# Milldale Fast-Track

29/07/2025 – Auckland Council Response

**Technical Specialist Memo – Parks Planning**

Fast-Track project name: Milldale

Figure 1: Redesigned distribution applying 450m catchment).

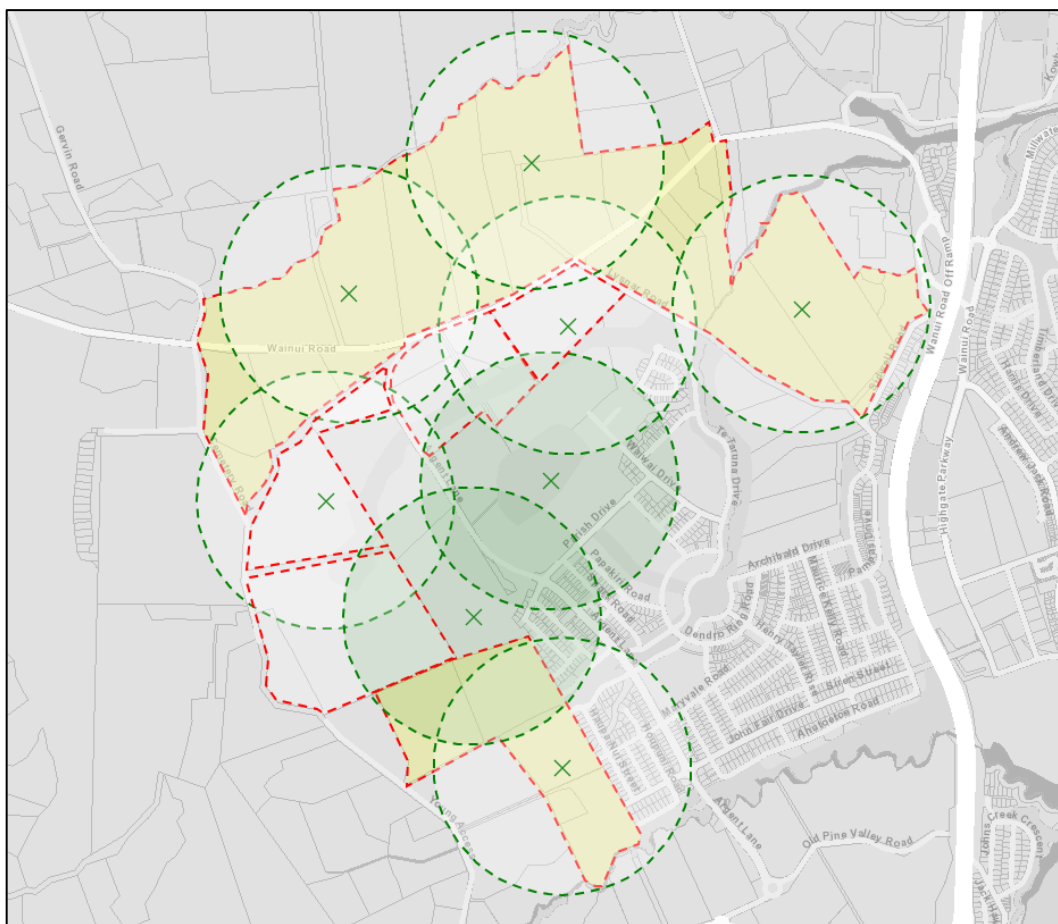
- 4.2.1 The scheme plan proposes two neighbourhood parks, Lot 7000 (Stage 10 - 3,107m<sup>2</sup>) and Lot 7002 (Stage 12 - 3,852m<sup>2</sup>), to be vested to Auckland Council as 'land in lieu of reserve'. These parks are strategically positioned to serve the broader subdivision stages. Council's Principal Property Provision Specialist, Rahman Bashir, has confirmed that their locations align with the Open Space Provision Policy 2016, applying a 450m pedestrian catchment (ped-shed) suitable for Milldale's low-density context as per Figure 1 below. In addition, the application of a low-density catchment ensures that the open space network is appropriately serviced with each proxy as seen in the re-designed network in figure 1, which includes the future urban zone to the north and east of the Fast Track site boundaries.

- 4.2.2 According to the Open Space Provision Policy 2016, neighbourhood parks should typically range between 0.3 to 0.5 hectares (3,000–5,000m<sup>2</sup>) and be situated within a 400–600m walking distance from residential areas, depending on density. The proposed parks meet these criteria and are co-located with local purpose drainage reserves, enhancing outdoor amenity and connectivity across the development.

- 4.2.3 In addition, key metrics such as the total lot size, kick ball area, and the gradients associated with the Open Space Provision Policy (2016) have been met as confirmed by Mr Bashir. Healthy Waters have confirmed the flood risk to the neighbourhood park locations is low and the 1% AEP is contained within the adjacent stream corridors that does not encroach into the two parks.

Figure 2: Bridge 3-5 connections.

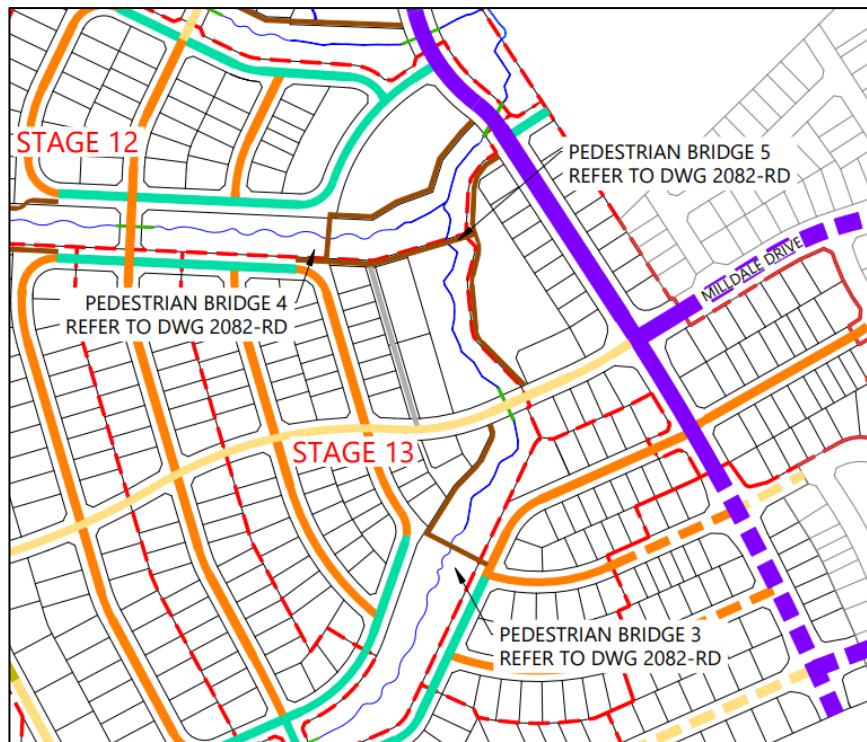
4.7.4 According to the applicant's assessment, Bridges 4 and 5 are proposed to serve dual functions. Bridge 4 is associated with stormwater infrastructure, while Bridge 5 accommodates wastewater infrastructure. Both bridges are also intended to provide pedestrian and active mode connectivity while screening the necessary pipe connections. In discussion with Council's Principal Urban Designer, Mustafa Demiralp, Bridge 5 is considered a duplication of access already provided via the reserve path that connects to the same collector road. The specific role of Bridge 5 as a pedestrian and/or active mode link also remains unclear.

Figure 3: Shared path connections and active mode loop connections.

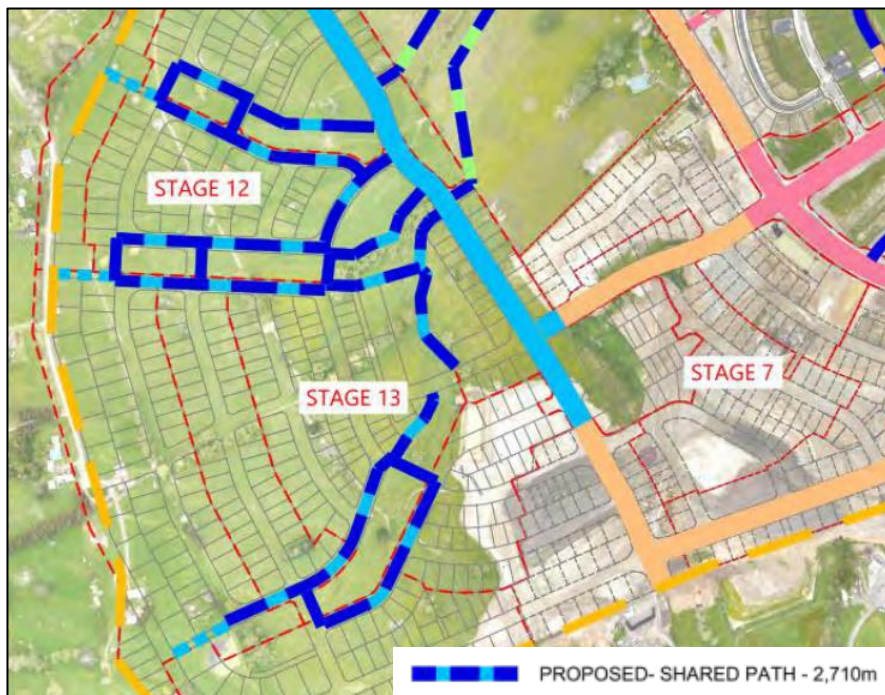
4.7.5 If, as shown in Figure 3 below, Bridge 5 is intended to function as an active mode and shared path connection (supporting both cycling and pedestrian use), this matter is to be deferred to Auckland Transport. From a Parks Planning perspective, Bridge 5 is considered to be a duplicative structure, particularly where Bridge 4 is provided, whereby Parks and Community Facilities does not seek ownership of Bridge 5. All other bridges are considered road-to-road connections, except for Bridge 1, which is a road-to-reserve connection. Bridge 1 is intended for pedestrian use only, as outlined in Appendix 2N of the Transport Assessment, and will be vested with Parks and Community Facilities.
